ENCLOSURE License No. DPR-31, DPR-41 & DPR-67  
Appl for Amend: tech specs proposed change  
concerning revision of Figure 6.2-1 to reflect  
recent minor changes to the offsite organization..  
Notorized 09/06/77...w/att Cert of Svc...

PLANT NAME: TURKEY UNITS 3 &amp; 4

Re: Turkey Point Units 3 and 4 and  
St. Lucie Unit 1, Docket Nos. 50-250,  
250-251 and 50-335 - Proposed Amendment  
to Facility Operating Licenses DPR-31,  
DPR-41 and DPR-67

FIGURE 6.2-1 OFFSITE ORGANIZATION CHART

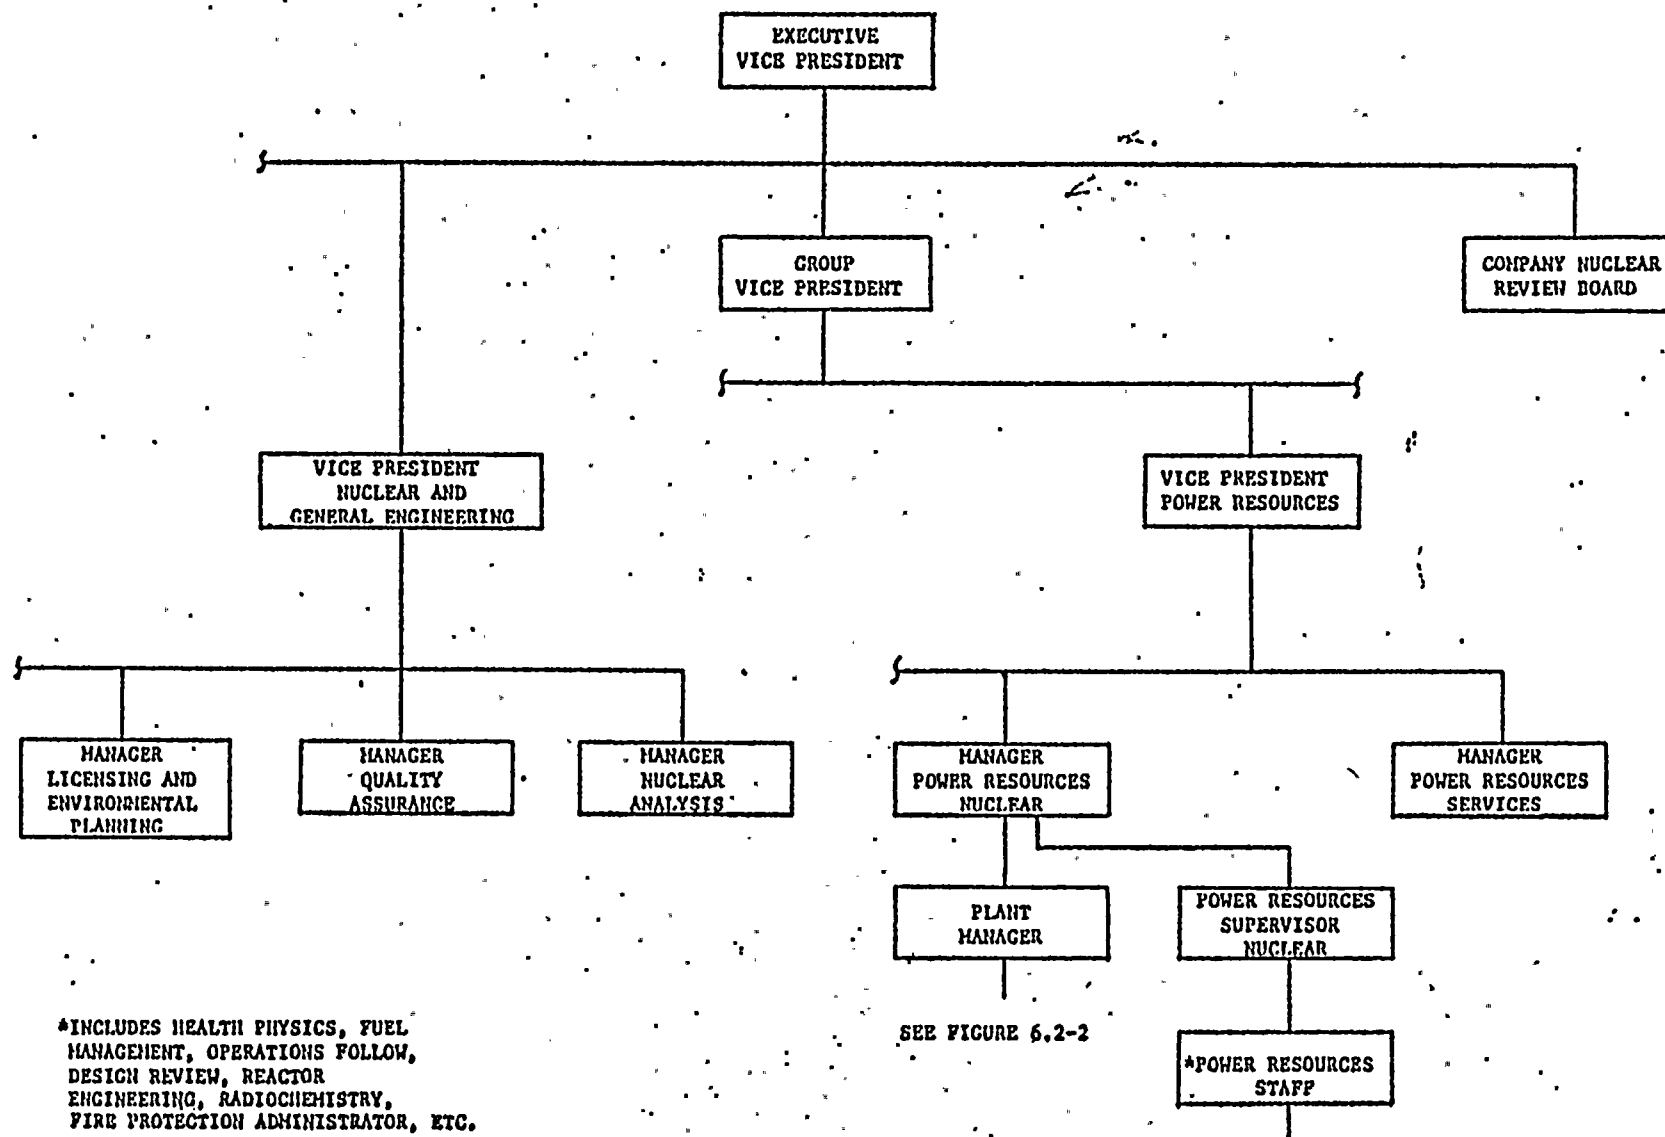
Figure 6.2-1 is revised to reflect recent minor changes in our offsite organization. Two positions have new titles (Vice President-Nuclear and General Engineering and Manager-Licensing and Environmental Planning). One position has been deleted (Vice President-Environmental Planning & Research).

Figure 6.2-1 on page 6-2 should be changed to reflect minor changes in the Florida Power & Light Company (FPL) offsite organization for management and support of nuclear facilities. Two positions have new titles and one position has been deleted as described in the cover letter.
